PLANNING REPORT

Planning and Zoning Commission

Emerald Parkway Mixed-Use 25-099CP

Case Summary

4. Project

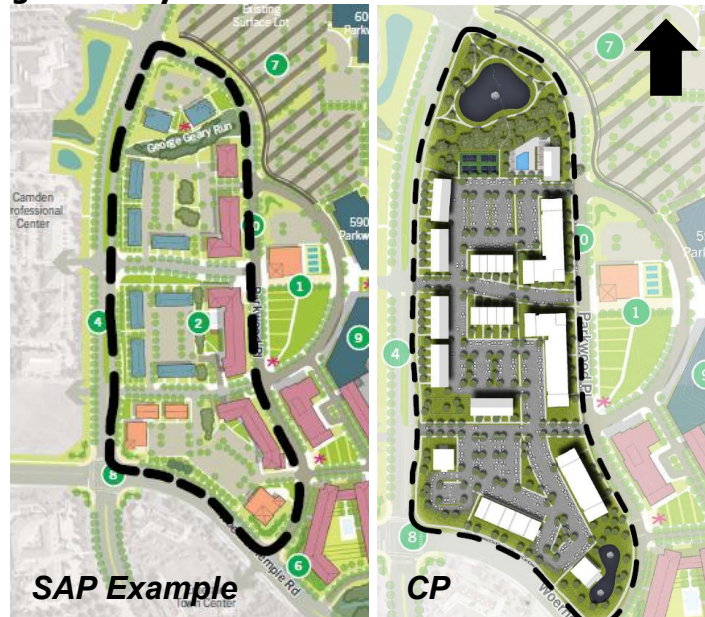
The proposed development has been designed to closely resemble the building and street layout of the SAP. The site includes 2 new streets that will connect Emerald Parkway to Parkwood Place. Buildings are proposed along the public and private street frontages, with parking and drive aisles internal to the site. The deviations from the SAP conceptual example are in the northern portion of the site, where a proposed park and clubhouse would be located, and the orientation of commercial buildings in the southern portion of the site addressing Emerald Parkway / Woerner Temple Road rather than the internal

streets. Buildings are set back approximately 30 feet from the perimeter roads, which is generally consistent with the SAP conceptual example. However, this does differ from the recommendations of the Multi-modal Transportation Plan, which recommend 100 feet along Emerald Parkway and Woerner Temple Road.

The Commission should consider whether they support the general layout of buildings, parking, and streets on the development, and whether the location of buildings along the perimeter of the site are set back appropriately for a mixed-use development.

The development includes multi-family residential, townhome residential, and commercial/office spaces. These uses generally align with the recommendations of the Emerald Corridor SAP. The applicant is proposing four, 3-story townhome units along Emerald Parkway, three, 3-story townhome along two new east-west streets internal to the site, and three, 4-story multi-family buildings along Parkwood Drive. Three commercial buildings with two possible drive-throughs are proposed in the southern portion of the site.

The Special Area Plan recommendations call for a retail/commercial cluster at the Emerald/ Woerner-Temple intersection and shared surface parking to the rear, which is generally consistent with what is proposed. However, the proposal includes two drive-throughs, one of which is proposed directly at the intersection. The SAP recommends that gateway landscaping and building features should address the intersection of Emerald Parkway and Woerner-Temple Road. Each tenant space is below 10,000 square feet, which aligns with the recommendations of the plan. The Commission should consider the location of buildings addressing the street and whether drive-throughs should be considered with this development.

fronting Emerald Parkway. A total of 248 residential units are proposed. Residential is considered appropriate for the site and is conceptually shown in the SAP along Parkwood Place in larger multi-family buildings. Limited office is proposed on the site. The proposed townhomes would be located across residential-scaled neighborhood office buildings. The Commission should consider whether residential is appropriate along Emerald Parkway and whether it offers an appropriate transition to the neighborhood office west of Emerald Parkway.

The four townhome buildings fronting on Emerald Parkway as well as the one along the southern private street are proposed as 3 stories with tuck-under parking. They feature a variety of building materials, consistent window placements, and front / side gable roofs. The remaining two townhome structures in the middle of the site conceptually show similar building materials but with flat roofs. The character of the 4-story multi-family residential buildings differs from the townhomes, as the materials are darker, the buildings contain more balconies, and projecting cornices are proposed at the ends of each building. The commercial buildings in the southern portion of the site will be single-story structures with significant storefront windows, natural building materials, flat roofs, and a variety of canopies and awnings.

The development includes a variety of public open spaces, including a 120,000 square-foot public park in the northern portion of the site. The public park contains a proposed stormwater retention pond, the George Geary Ditch, walking paths, and the preservation of existing mature trees. Adjacent to the park are proposed pickleball courts and amenity space for residents. Additional open spaces throughout the site include a dog park and passive spaces adjacent to the multi-family buildings. Sidewalks are provided throughout the site both along all public and private streets, and between residential buildings to connect the southern portion of the site to the northern portion.

The SAP recommends the preservation of existing tree stands that are located along a north/south line at the center of the site. As currently proposed, many of these trees would be removed, except for the trees in the northern portion of the site. The Commission should consider whether the proposed open spaces on the site are appropriately located and sized on the site, and whether the removal of the existing tree stand at the center of the site is appropriate.
